UNITED STATES PATENT AND TRADEMARK OFFICE

APPLICATION NO.	FILING DATE	FIRST NAMED INVENTOR	ATTORNEY DOCKET NO.	CONFIRMATION NO.
10/720,497	11/24/2003	Antoni Zawadzki	ZawadzkiA_P_1_03	9408

Office Action Summary

DETAILED ACTION

Diagram 1. Figure 11 in Goodwin.

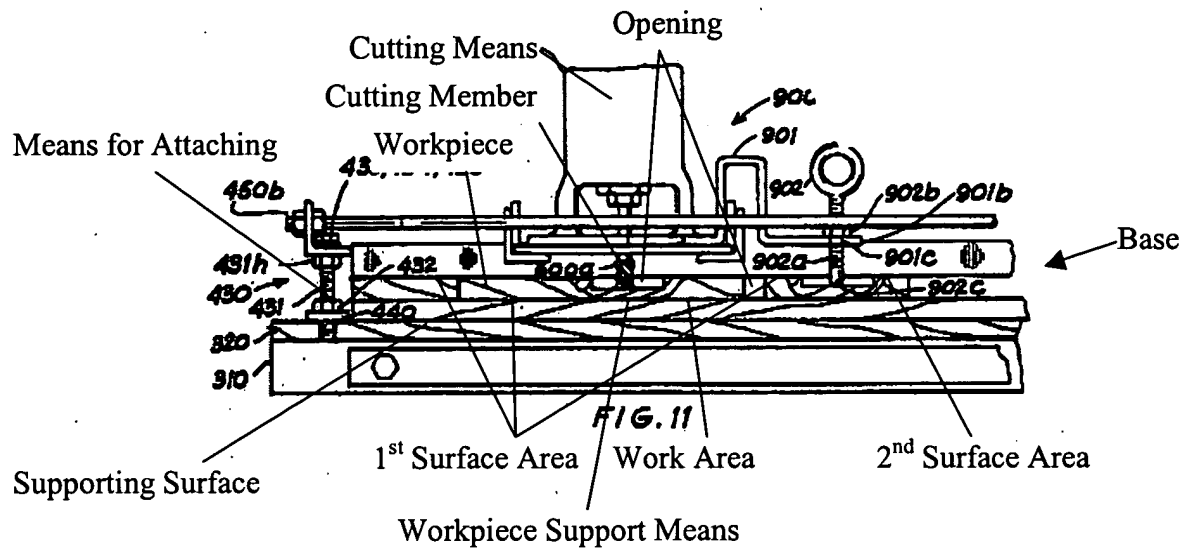
4. Claims 1, 2, 6-12 and 16-20 are rejected under 35 U.S.C. 102(b) as being anticipated by Goodwin (5,203,389). Goodwin discloses everything as shown below in diagrams 1 and 2, and also discloses router 600, 600a; wood as shown by the texture of the elements in figure 10; . It is to be further noted that regarding claims 7 and 8, the methods of manufacture i.e. molding and casting, do not further limit the structure of the apparatus.

Diagram 2. Figure 10 in Goodwin.

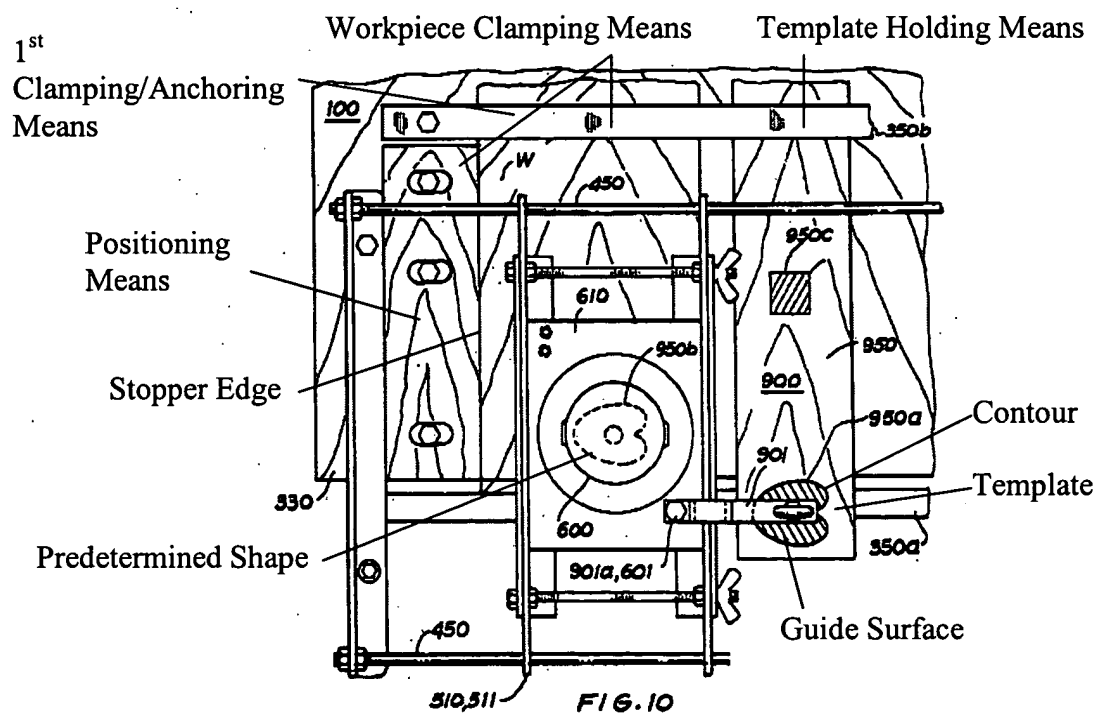
6. Claims 3 and 13 are rejected under 35 U.S.C. 103(a) as being unpatentable over Goodwin in view of Mecsey (4,355,557). Goodwin discloses everything as noted above, but does not disclose a second clamping means. However, Mecsey teaches second clamping means 165, 166, 168, 170, 172, 173 and 175. It would have been obvious to provide a second clamping means in Goodwin as taught by Mecsey in order to secure the workpiece in a horizontal direction opposite the stopper edge. Note that the second clamping means is mounted on the template on the far side of the element 350b from the cutting means as shown in figure 10 in Goodwin.
